SERVICE BULLETIN MAINTENANCE OF WAY EQUIPMENT

DATE:	8-5-2003			BULLETIN NO:	03-014
TITLE:	SOLID S	LID STATE ENGINE SOLENOID MOUNTING			
RATING:		DIRECTIVE (Action Is Required)	X	ALERT (Potential Problem)	
		INFORMATION (Action Is Optional)		PRODUCT IMPROVEMENT (Enhance Product)

PRODUCT SERIES / MODEL: 6700S Tampers

FIGURE 1 ANGLE BRACKET RE-WORK

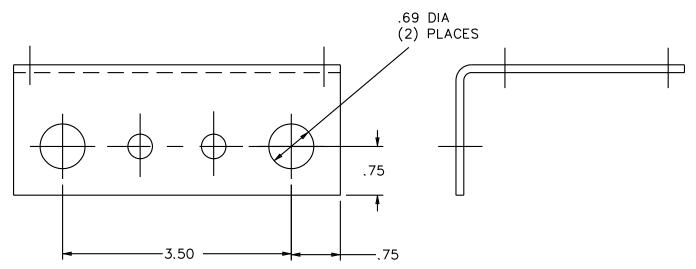
- 6. Re-work the angle bracket (B) by adding two 11/16 inch diameter holes per the dimensions shown in Figure 1.
- 7. Mount the angle bracket (B) to the two bottom holes on the side of the pump drive as shown in Figure 3 using two 5/8"-11 x 1" long cap screws (1).

FIGURE 3 NEW MOUNTING OF SOLENOID AND BRACKET

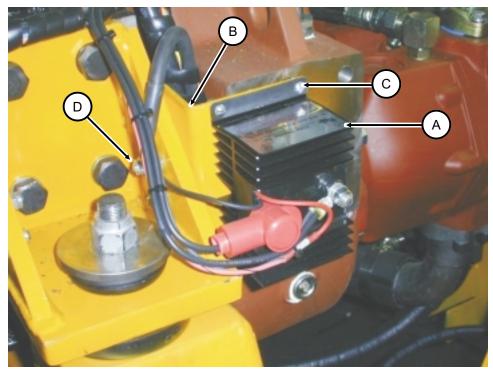
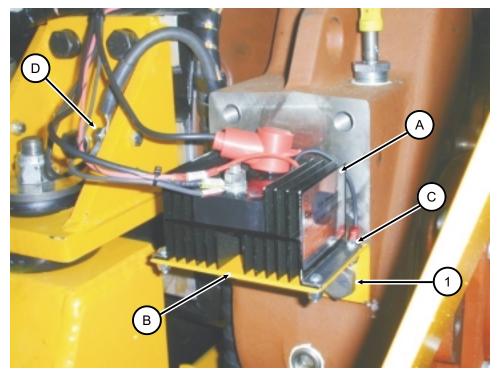
- SERIAL NO: All Models Serial # 153045 and Higher
- **SUMMARY:** There have been several instances where the mounting feet of the solid state engine solenoid have broken off leaving the solenoid dangling and the wires loose. It is felt that this may be due to the vertical mounting position of the solenoid on the side of the angle bracket attached to the engine mount. It has been determined that a better mounting position would be to attach the angle bracket to the side of the pump drive and mount the solenoid horizontally so it is resting on the top of the angle bracket.

- ACTION: The remounting of the solenoid requires removing the solenoid and bracket from its original mounting location on the engine mount, adding two new mounting holes in the bracket, remounting the bracket in a new location on the side of the pump drive, and then re-installing the solenoid on the bracket.

- Install the solenoid (A) to the angle bracket (B) re-using the four cap screws and nuts (C). BE SURE to install the solenoid ground wire under one of the four screws (C).
